Memorandum to the City of Markham Committee of Adjustment

File: A/130/21
Address: 8 Galsworthy Drive – Markham, ON
Applicant: Mark Li
Agent: Yinghuan Weng
Hearing Date: March 23, 2022

The following comments are provided on behalf of the East District Team. The applicant is requesting relief from the following “Residential One – (R1)” zone requirement under By-law 1229, as amended, as it relates to a new two-storey detached dwelling, to permit:

Site Plan

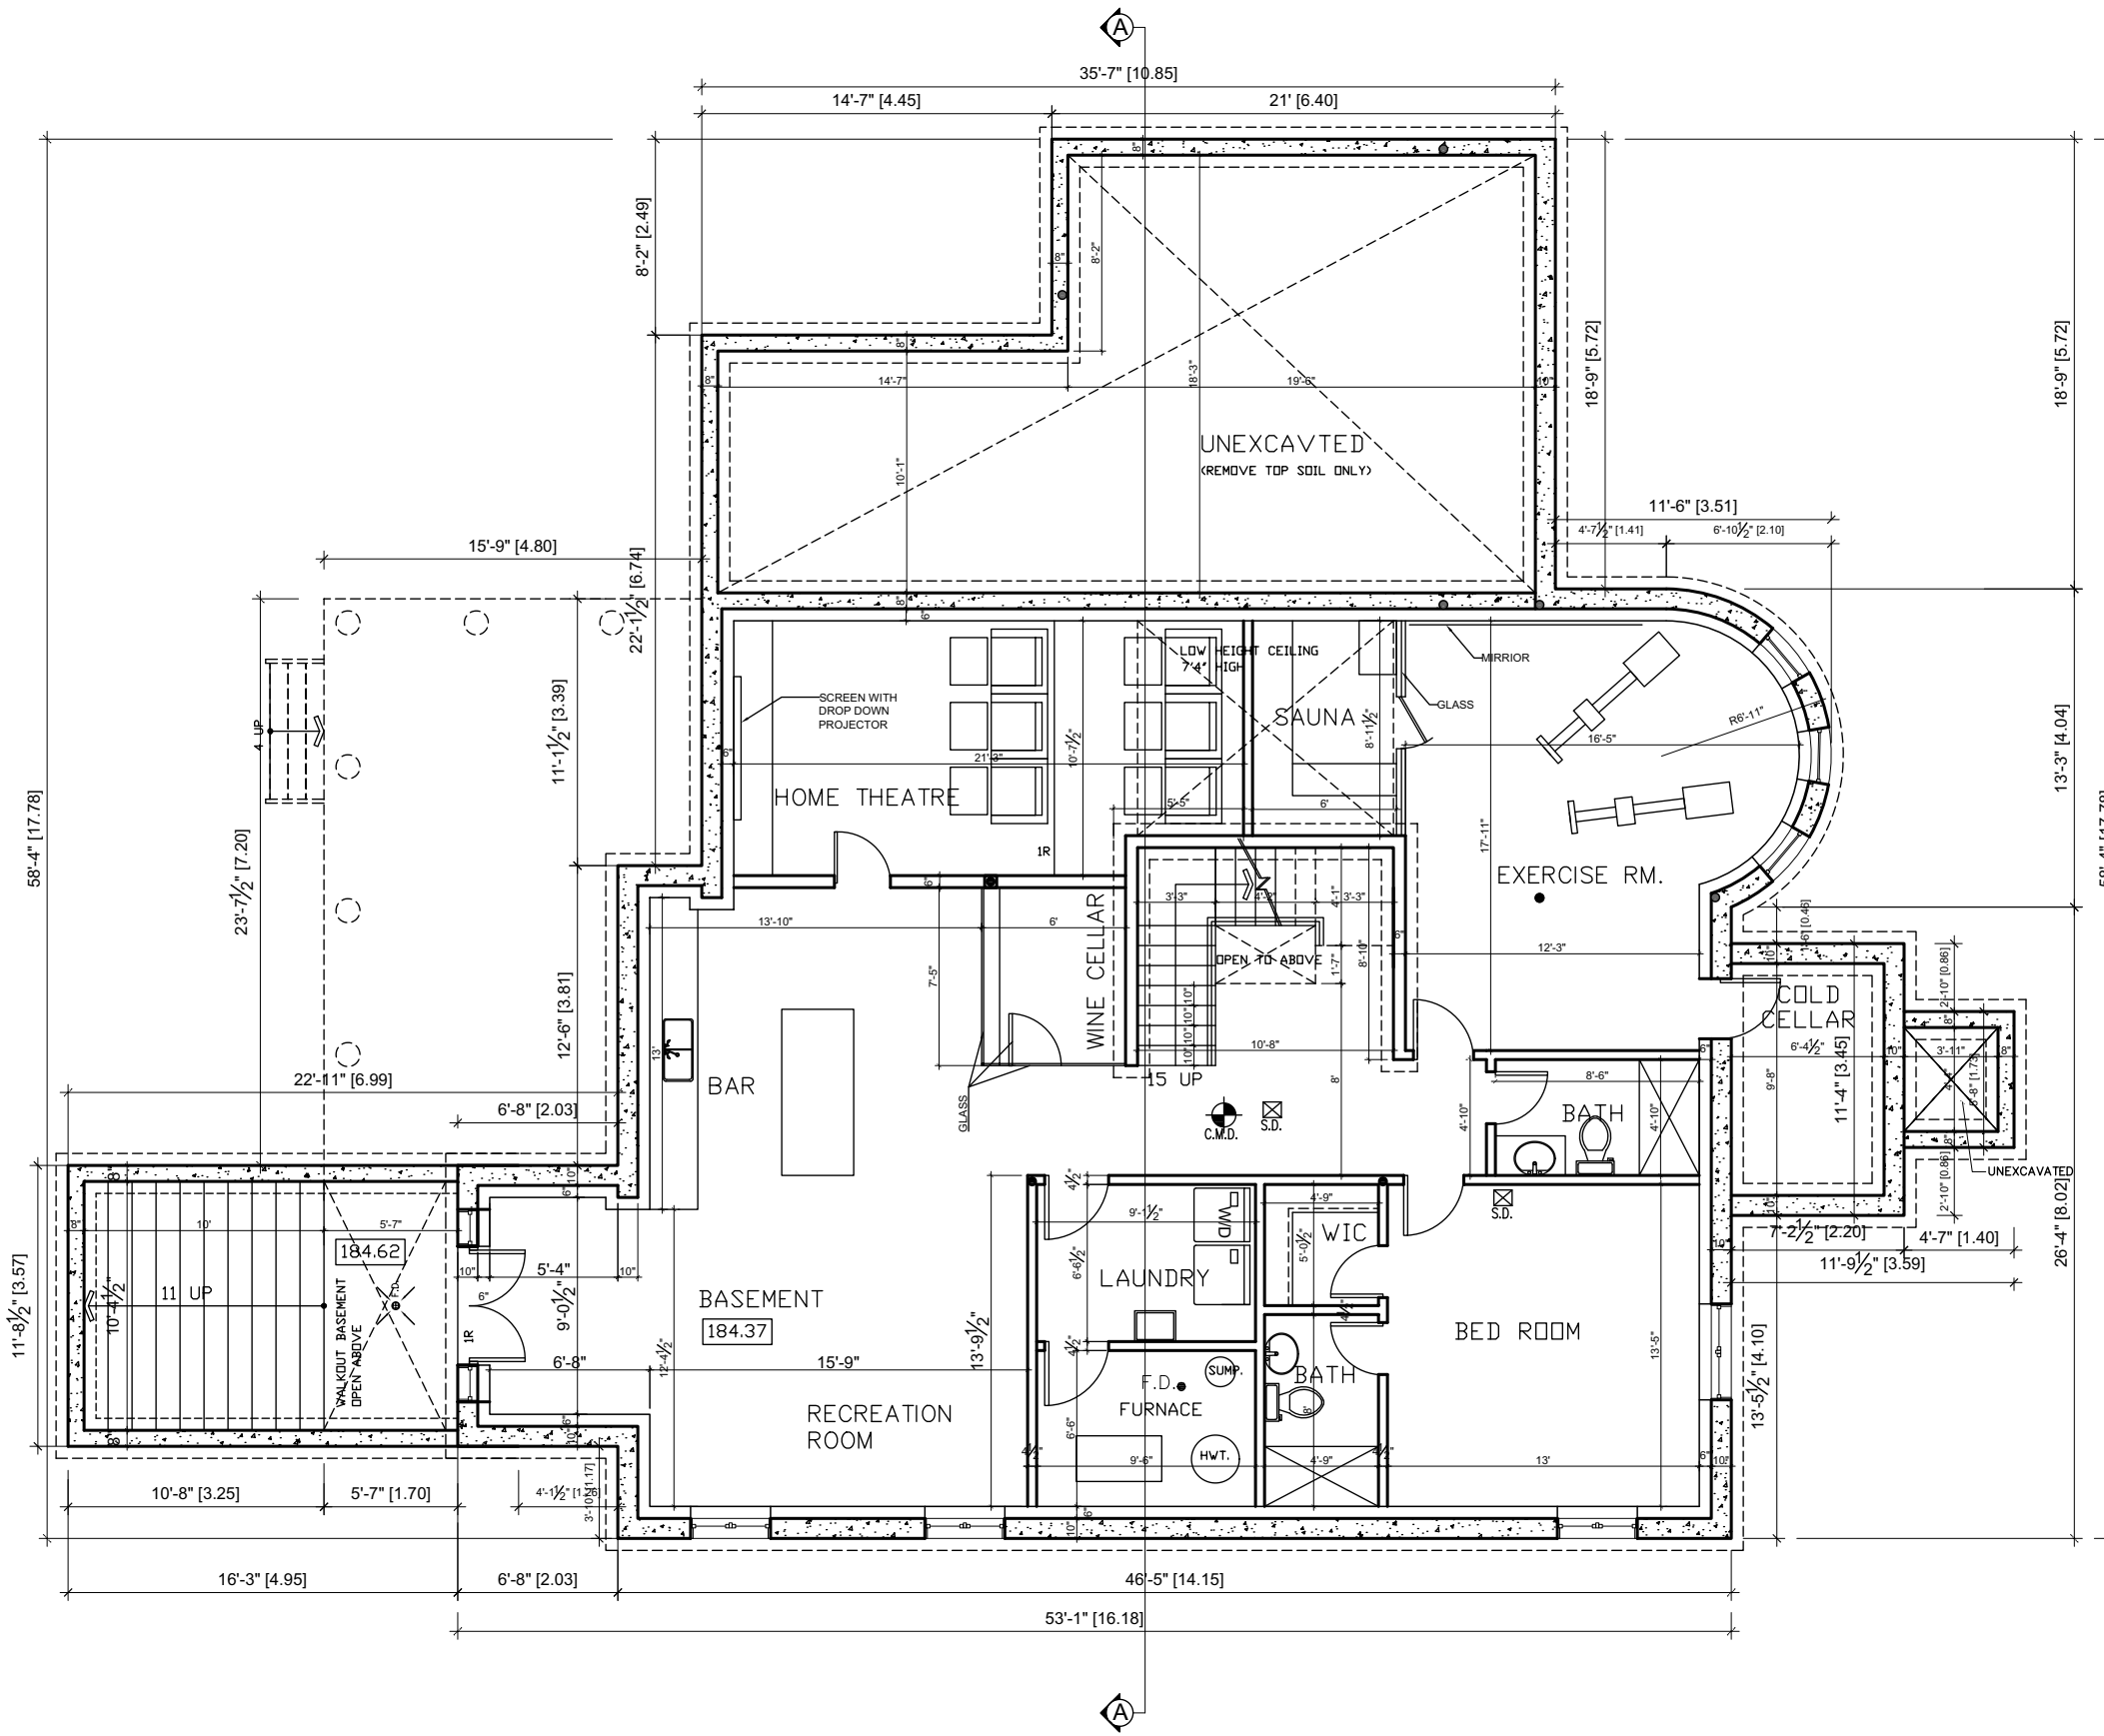
The applicant is no longer requesting an increase to the maximum height or maximum depth, and has reduced their request relating to a maximum floor area ratio from 52.90% to 49.78%. The dwelling has a new building depth of 18.29 m (60.01 ft), which would comply with the By-law exception that allows for a maximum building depth of up to 18.90 m (62.01 ft), provided all criteria for an extension to the rear of the dwelling are met (see criteria outlined in initial staff report). The proposed development meets all other zoning provisions that establish the prescribed building envelope, and staff remain of the opinion that the proposed development meets the four tests under the *Planning Act, R.S.O. 1990, c. P.13, as amended*.

DRAWING: **Site Plan**

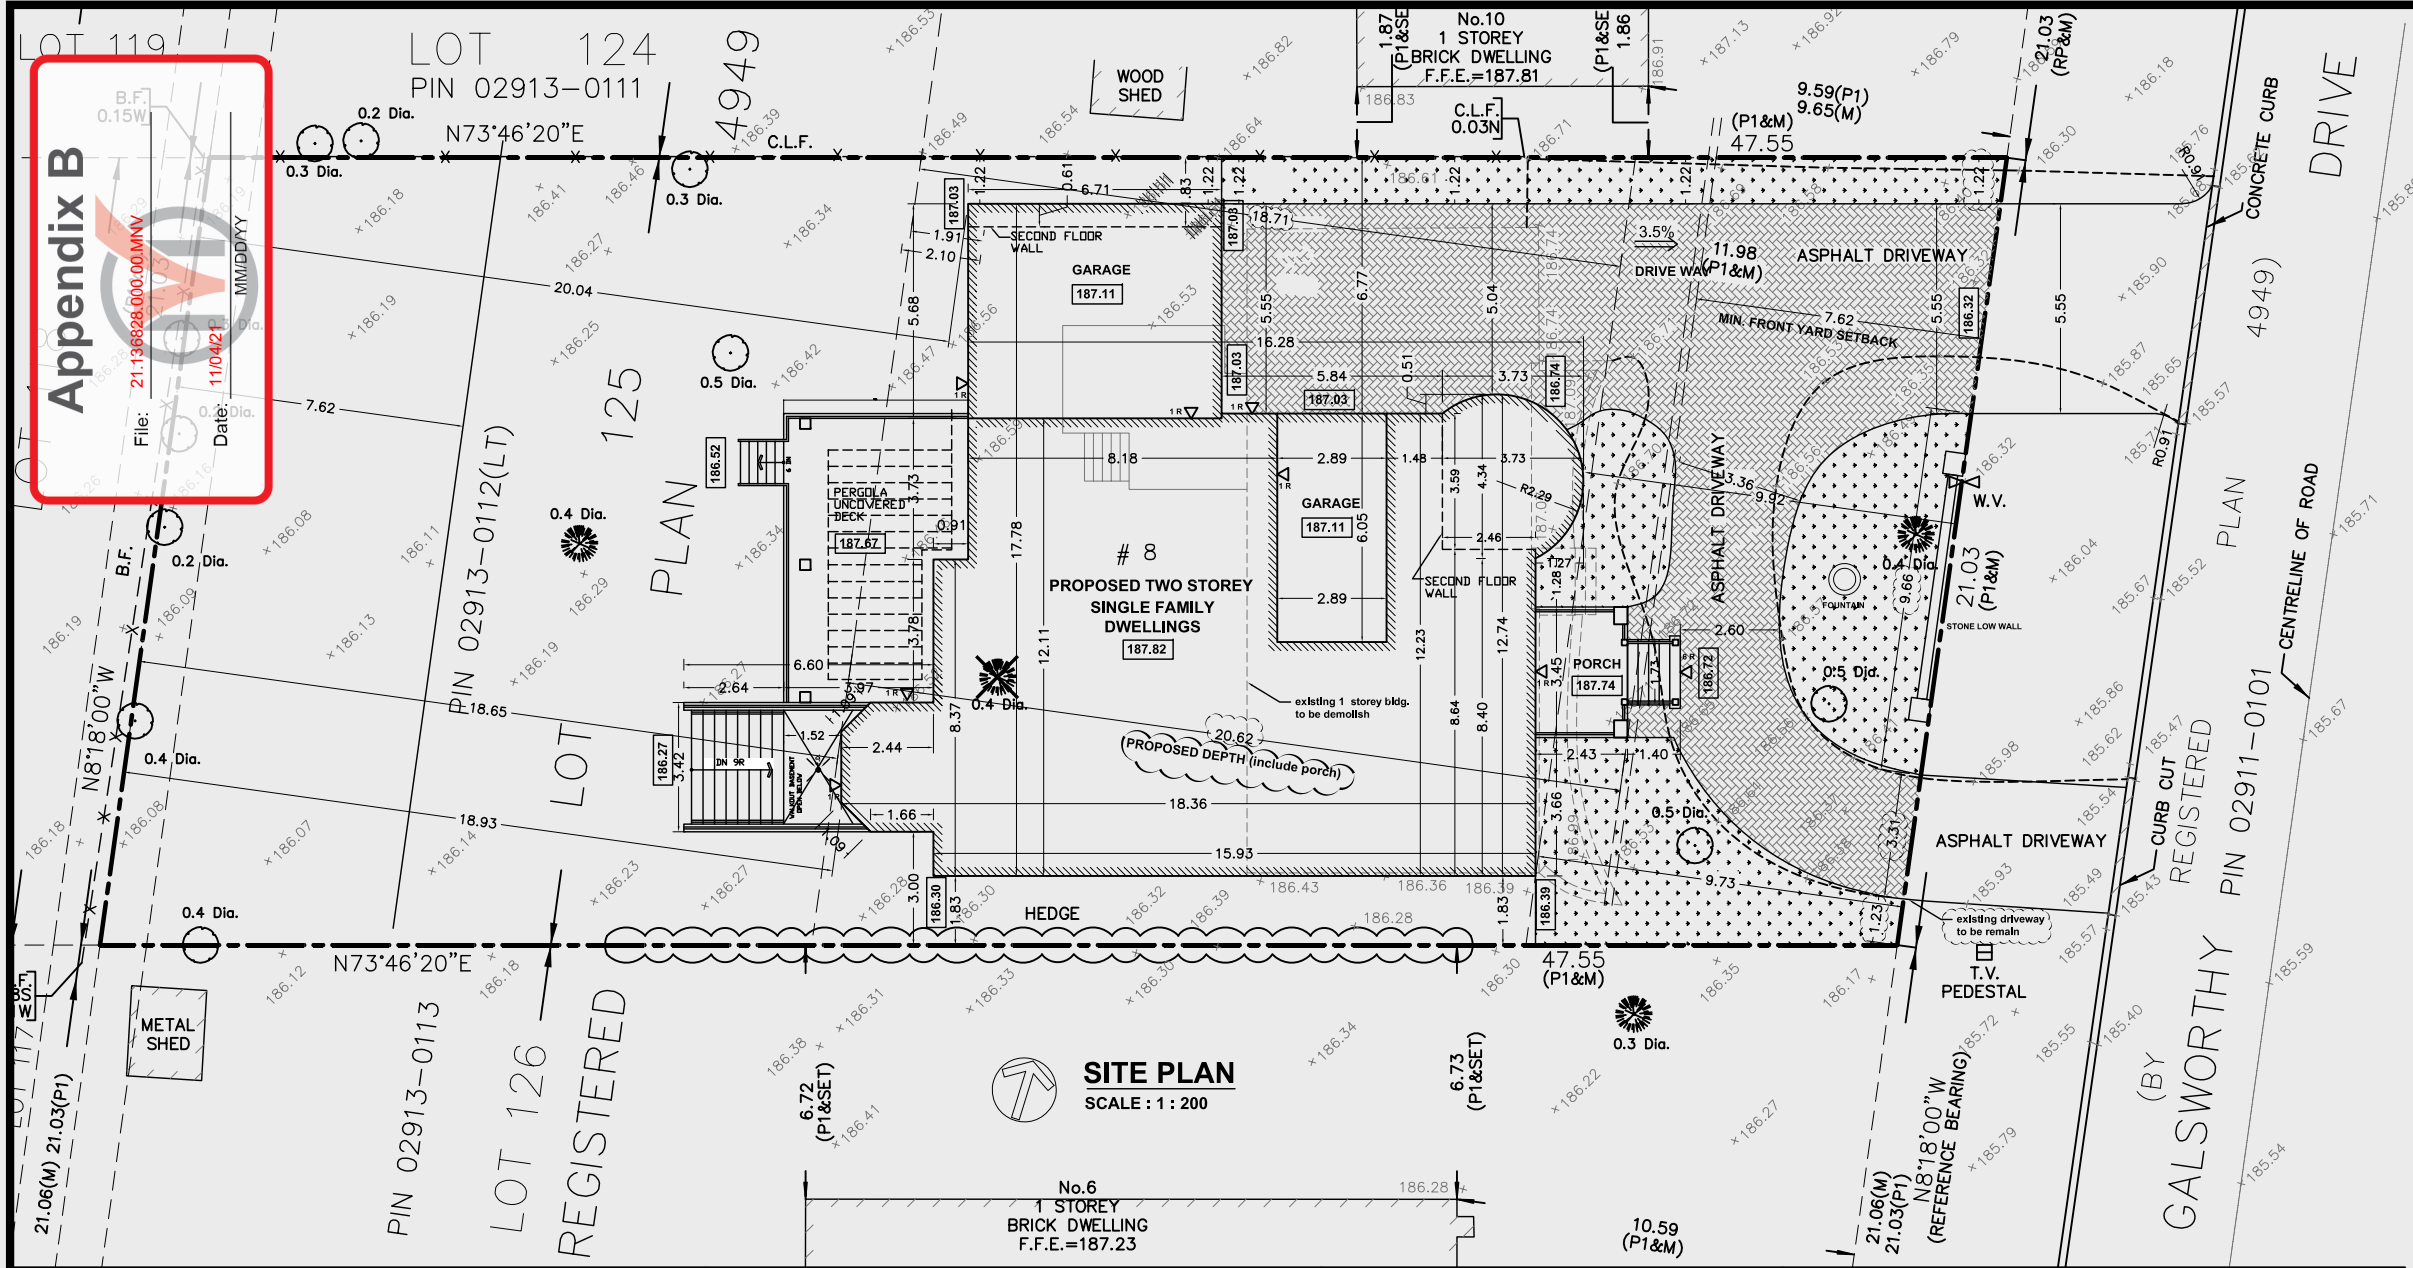
As the property's front and rear lot lines are angled, the building depth measures 20.62 m (67.65 ft) as shown in the Site Plan (Appendix "B"). Staff are of the opinion that the rear balcony appropriately maintains the intent of the By-law, as it generally meets the criteria for extensions. Staff have also given consideration to other elements which assist in breaking up the mass of a building, including stepbacks, setbacks, and the location of the front covered porch which extends beyond the maximum permitted building depth. Staff have no objections to the requested variance.
